15 May 2015

Electricity Demand and Generation Scenarios  
Ministry of Business, Innovation & Employment  
By email [EDGS@mbie.govt.nz](mailto:EDGS@mbie.govt.nz)

### **Draft Electricity Demand and Generation Scenarios**

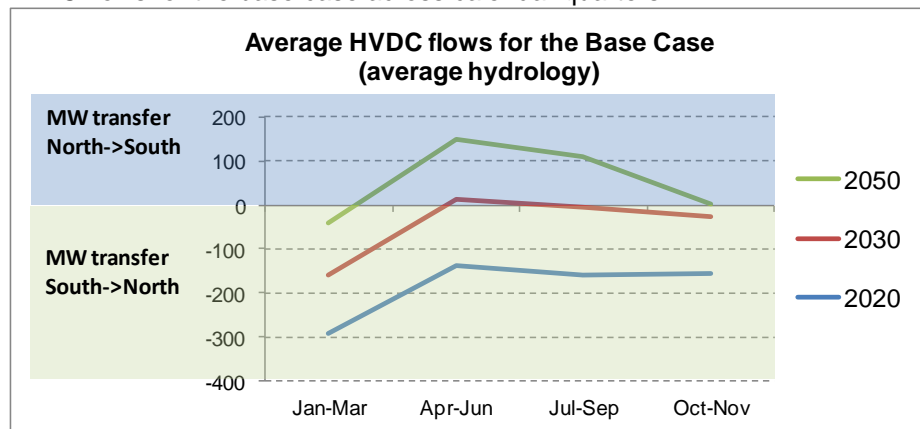
**Model calibration.** There is value in simulating core scenarios with a reservoir optimisation model to ensure key outputs (e.g., lost load, meeting peak demand, wholesale prices, spill, revenue adequacy, location factors) are feasible and sensible. As a simple example, we understand that location factors are assumed to be constant the GEM simulations. This is a material driver of relative economics of new builds. A key driver of those is the supply balance between the North and South Islands as this drives the wholesale price differences and is likely a factor in new builds being dominated by North Island projects. Following the workshop, MBIE published HVDC flow information<sup>2</sup> and the chart below depicts the change in average HVDC flows for the base case across calendar quarters.

This illustrates that over a relatively short time (in terms of generation and transmission planning), average HVDC flows are expected to transition to neutral for a large part of the year (2030) then *southwards*, which has flow on effects for modelled location factors, expected prices, new generation builds, and ultimately transmission requirements. MBIE needs to account for this in their modelling.
